Beam dump matrix modifications of the WIC in the PSB and PSB extraction lines

Machine Protection Panel Meeting (Injectors) #218, 17th December 2021

Why proposing changes to the PSB WIC dump matrix?

Multipoles for Resonance Compensation (II)

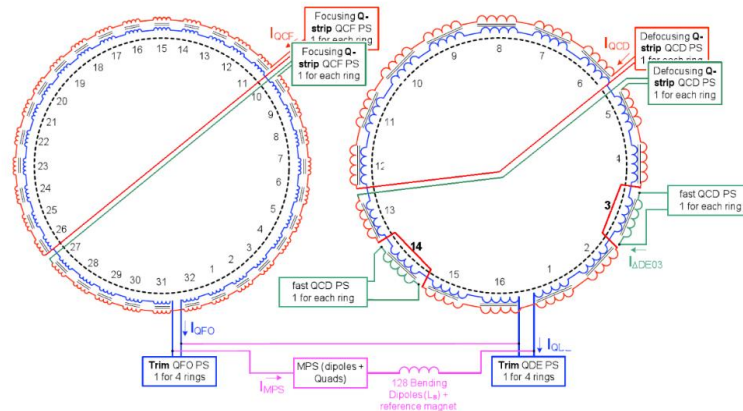
- **Proposal to disable** the WIC 'User_Permit' signal sent to the BIS of the normal quadrupole converters **QNO 311L1, 412L3, 816L1, 816L3** in the PSB.
- Original **inclusion was based on the pre-LS2 resonance compensation scheme for half integer resonance.** → Currently we **do not inject above the half integer**. Not clear if we will ever do it.
- If we are ever going to inject above the half integer, and lose one of the multipoles, most - if not - all the beam will be lost. These **losses are equivalent to ones that we currently experience** in the PSB, because of other equipment, e.g. the TFB (example below from a problem in R4 in Nov. 2021).
- No additional danger for the equipment, beyond what is already happening on a yearly basis.

- Based on ABP studies, it should be **possible to compensate for a non-working multipole power converter from this list with others** to restore an acceptable compensation of the resonances.

- In the worst-case scenario, it should be still possible to **provide beam with lower intensity** than the specifications (degraded mode) in the affected ring.

- Maintain the PSB availability → A failure in 1 ring won't block the entire proton chain and there is no additional danger for the equipment wrt what is currently happening.

- During a **transitional period of adjustment there might be increased beam losses which will be at the same level of the ones currently experienced because of other equipment. We judge that no additional danger is introduced by removing the aforementioned multipoles from the WIC.**

QSTRIPs (II)

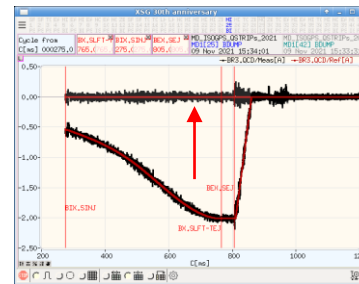
- **Proposal to disable** the WIC 'User_Permit' signal sent to the BIS.
- Original **inclusion based on the pre-LS2 operational experience**: Pre-LS2, the PSB would rely on the **QSTRIPs to tweak the injection tune in order to optimize injection transmission**.
- Currently with the **new tune controller and injection schema**, they are powered at very **low current** as we generally use the same tune for all rings given the beam type.
- To validate the proposal, **an MD was carried over in ring3** with a high intensity beam, by disabling each of the chains one by one (**BR3.QCD, BR3.QCF, BR3.QCD3, BR3.QCD14**) and checking the losses and tune:
 - No significant impact in terms of losses in the ring.
 - No significant impact in terms of losses at extraction.
 - Link to MD test, [here](#).

Correctors in the PSB extraction lines

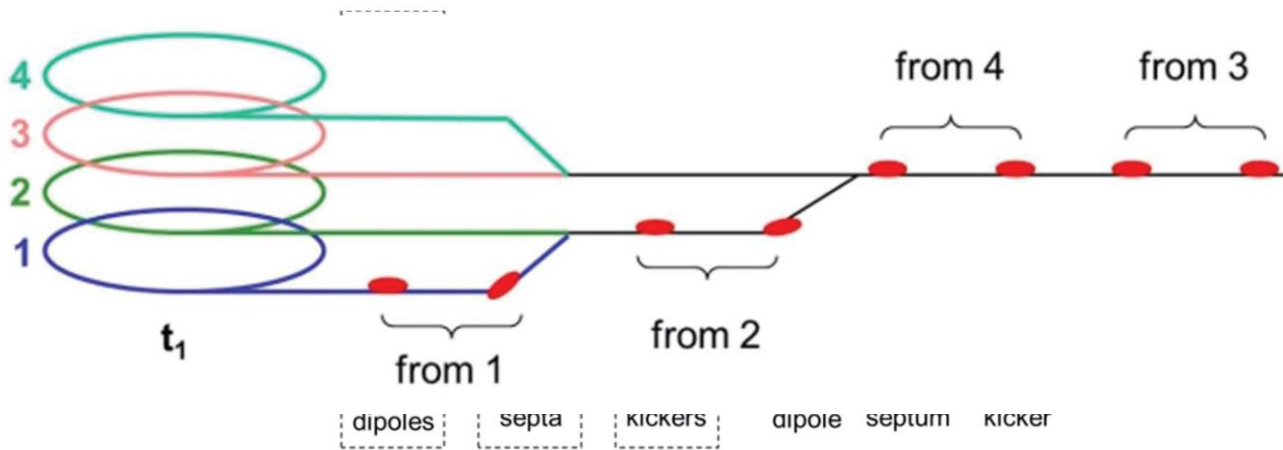
- **Proposal to disable** the WIC 'User_Permit' signal sent to the BIS for the correctors in the BT, BTM, BTP lines.
- Operationally, it should be possible to **compensate for a non-working corrector power converter from this list with others** to restore an acceptable beam trajectory along the extraction transfer line

- A **few tests have been carried over by the PS team** to verify that the PS injection could be recovered, even losing the most critical converters close to the PS injection, **BTP.DVT40 & BTP.DVT50**.

- During a **transitional period of adjustment there might be increased beam losses which will be at the same level of the ones currently experienced because of other equipment. We judge that no additional danger is introduced by removing the PSB-PS TL correctors from the WIC.**
